Form 3160-5 (June 2019)

Bennet Ranch Unit 25-1

Bennet Ranch Unit 25-1 API 30-035-20031

# Bennett Ranch Unit 25 25-1 30-035-20031 Heyco Development Corporation November 22, 2022 Conditions of Approval

### **WELLBORE DIAGRAM**

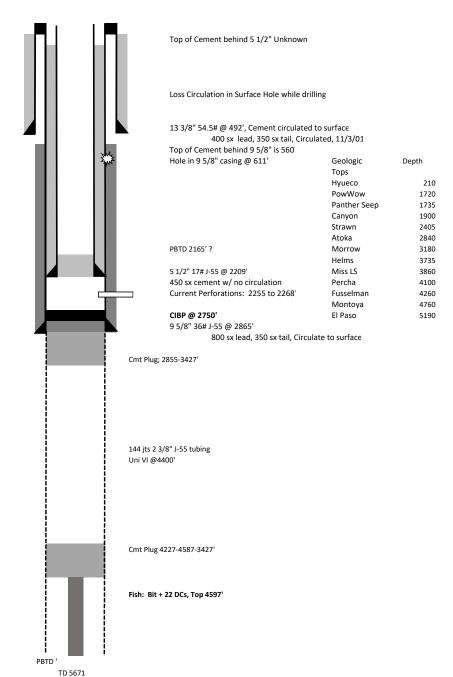
- 1. Operator shall place CIBP at 2,200' (50'-100' above top most perf) and place a minimum of 25 sx of Class C cement on top. WOC and TAG.
- 2. Operator shall perf at 542" and squeeze class c cement to 390" as proposed to seal the 9-5/8" casing shoe. WOC and TAG.
- 3. Operator shall perf at 100" and squeeze class c cement to surface as proposed.
- 4. Dry hole marker must be below ground.
- 5. Surface reclamation will need to be completed once the well bore has been plugged. Please contact <a href="mailto:lkeeven@blm.gov">lkeeven@blm.gov</a> for additional information.
- 6. See Attached for general plugging stipulations.
